New Field Safety Notice
Urgent Medical Device Correction - Grip Cable Failures
on da Vinci X and Xi Reusable Instruments with Jaws (ISIFA2024-09-C)

1- Introduction
and Reason for
Field Action

Figure A: 10x magnification of an example of an intact grip cable of a da Vinci Xi instrument.

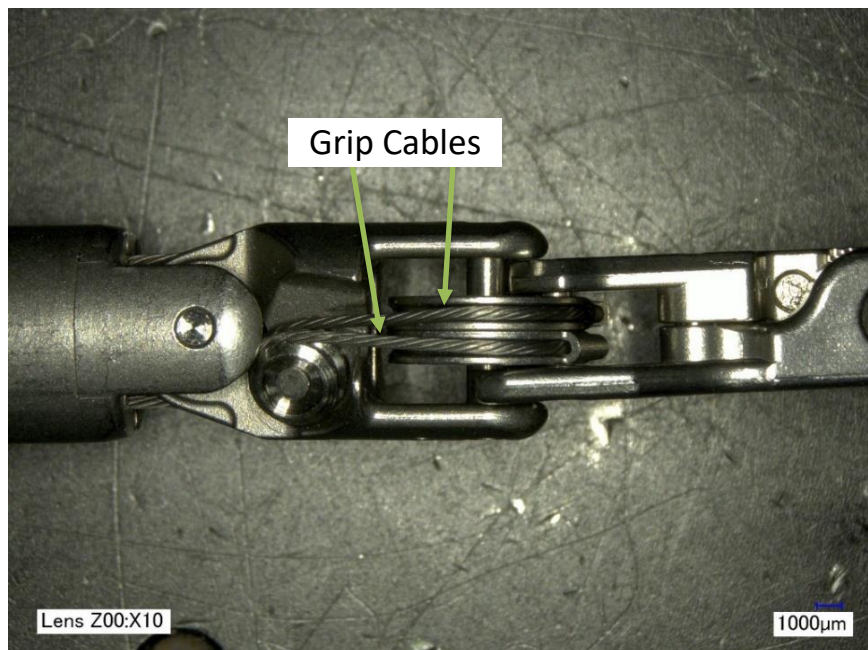
This Field Safety Notice is to notify you that Intuitive has become aware of an **increase in complaints** regarding frayed or broken cables on some da Vinci X and Xi reusable instruments. We refer to these frayed or broken cables as “failures”. There are two grip cables in the instruments which control the opening and closing of the jaws of the instrument (as shown in Figure A). The grip cable is the same across all da Vinci X and Xi reusable instruments with jaws.

Figure G: Location of Part, Lot and Version Number on Instrument Casing

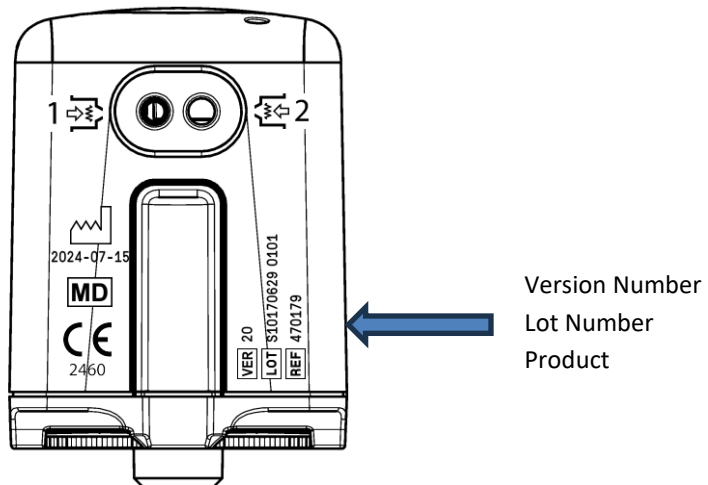
Please see photos below of where the version number is located on the instrument box (Figure F) as well as the instrument casing (Figure G).

Figure H: Broken Cable

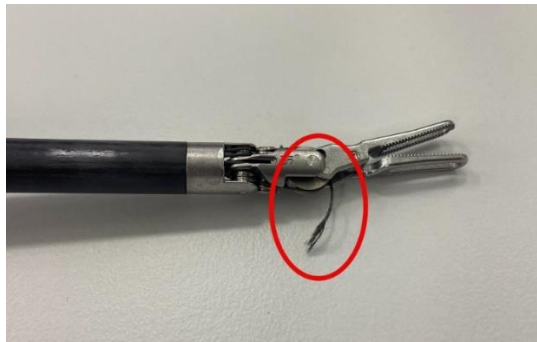
Prior to use, visually inspect all instruments for broken or frayed cable per Figures H & I below
